Answers to Reviews of “The ICAD (Iterative Cavity Enhanced DOAS) Method” AMTD2019

Martin Horbanski, Denis Pöhler, Johannes Lampel and Ulrich Platt

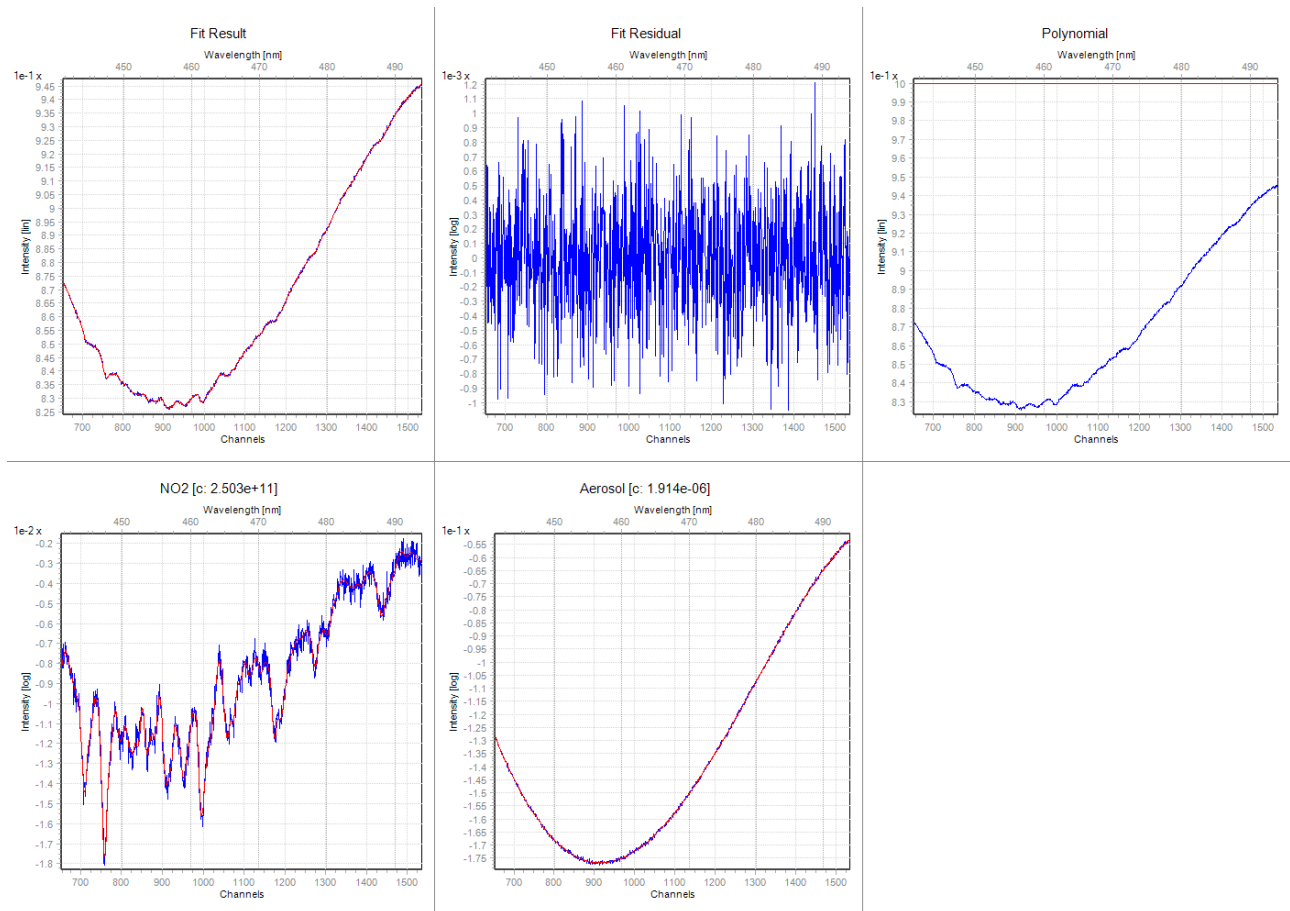
Page 8, lines 1 ff: The authors state that for cases when no particle filters in the inlet are acceptable due to trace gas losses on the surface the aerosol extinction term ϵ aerosol (m, λ) (Eq. 8) must be estimated 'by a suitable parametrization'.

However in Fig. 4 (first equation in the box) the broadband aerosol extinction ϵ_b (see Eq.5) or ϵ aerosol (m, λ) (see Eq. 8), respectively, is omitted. The authors justify this by simply stating (page 9,

- Please explain what is meant by 'suitable parametrization'.

- Could it be that in the case of strong aerosol extinction the iterative technique does not necessarily lead to a bijective solution?

We thank the reviewer for this useful comment. Our intention was not to confuse the reader with the iterative algorithm including aerosol absorption, since it is not the main part of the manuscript (in fact it could be the topic of another publication). But we agree that more general information should be given for the sake of clarity.

- We added the sentence

“Typically an Angstrom exponent approach $\epsilon_{aerosol}(m,\lambda) = m_1 \cdot \lambda^{-m_2}$ could be used.”

- We also included a Supplement Sect. S1 which gives a basic discussion of an ICAD approach which includes aerosol absorption.

Below we present a sample ICAD Evaluation for a simulated spectrum with aerosol extinction. Simulations are based on section 1.3 with 10ppbv NO₂ plus aerosol extinction with a typical Angstrom exponent of 1.7 and a peak aerosol optical density of 20% and Gaussian noise ($\sigma = 10^{-4}$). Fit settings are based on config 1 (Table 1). A broader fit range (441nm to 494nm) has to be chosen in order to include both wings of the aerosol fit reference (the shape of the aerosol extinction arises due to the mirror reflectivity), the DOAS Polynomial is set to first order and the High Pass Binomial filter is removed. The ICAD evaluation correctly retrieves (9.97±0.03)ppbv NO₂ which shows that the reduction of the light path by aerosol absorption is correctly accounted for by the correction factor K(λ). This demonstrate that ICAD can in principle also be used in the presence of aerosol extinction. Further studies with aerosol application are beyond the scope of this manuscript.

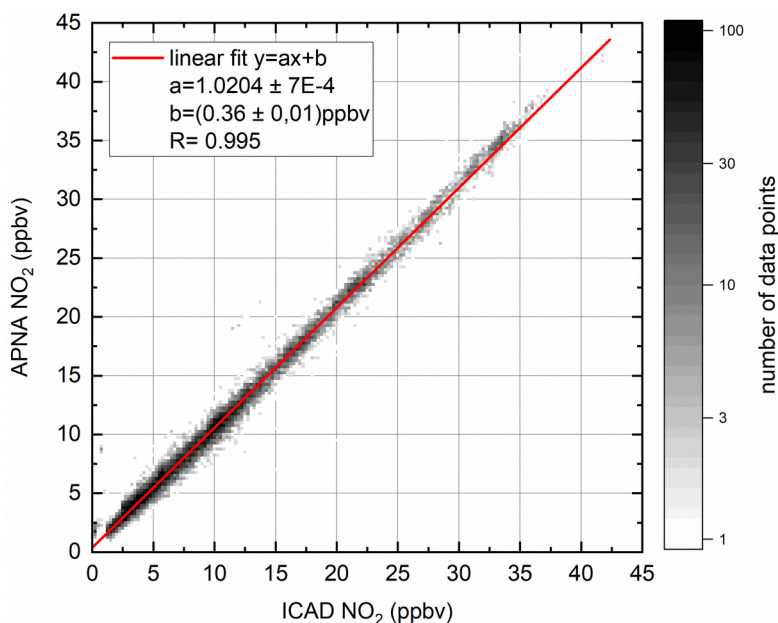
7. What causes the offset in the ICAD vs APNA 370 measurements? If there is residual NO₂ in the zero air, this should still be measured by both systems.

By looking at the measurements of zero air we see that the zero point offset of the ANPA is only (0.07±0.18)ppb and for the ICAD (-0.05±0.03)ppb. Therefore we think that the offset in the fit might indicate a very small non-linearity in the correlation between both instruments. This might come from some interferences of the APNA 370 to other gases in the ambient air.
